Re: Re-subdivision – Nottingham Hills Lots 19 & 21

To: Gary A. Goeschel II, Director of Planning
From: Victor Benni, P.E., Town Engineer 
Date: August 12, 2020
Re: 22 & 24 Upper Kensington Drive – Nottingham Hills
Subdivision Application Review

TITLE OF PLAN:	Conservation Design Development Nottingham Hills Subdivision; 4 lot Re-subdivision of Lots 19 and 21
DATE RECEIVED:	March 2020
DATE DISTRIBUTED:	May 2020
REVIEW DEADLINE:	July 7, 2020

TYPICAL HAY BALE INSTALLATION

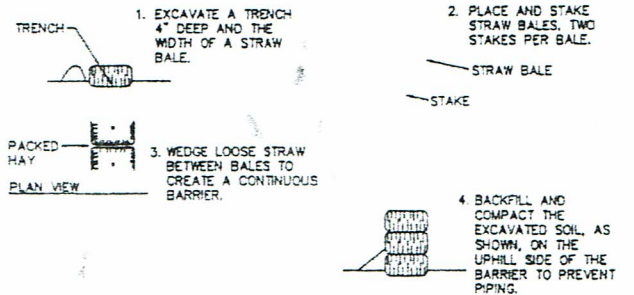
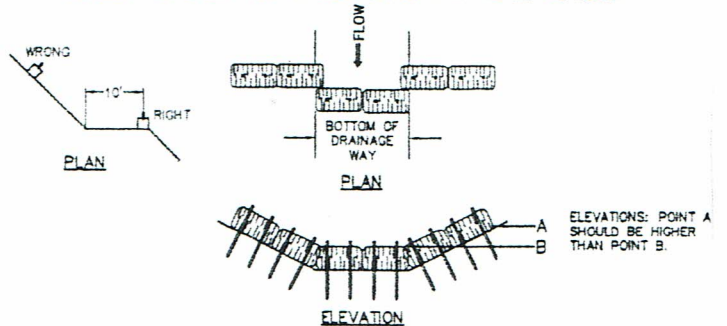
4. Erosion and Sedimentation and Control Plan

See attached Ex. 1 which will be added to a new page (Page 5 of 5) to this applications plans.

EROSION & SEDIMENT CONTROL NARRATIVE

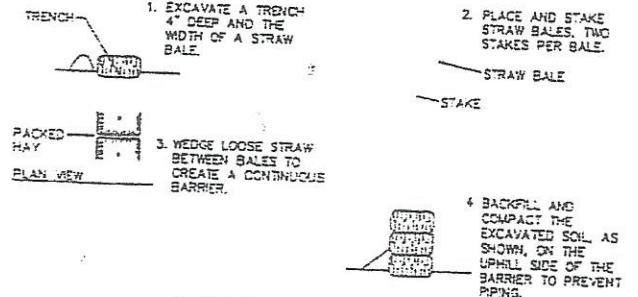
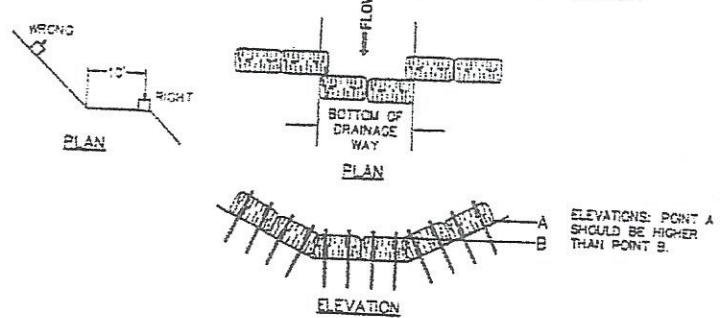
4. Erosion and Sedimentation and Control Plan

See attached Ex. 1 which will be added to a new page (Page 5 of 5) to this applications plans.
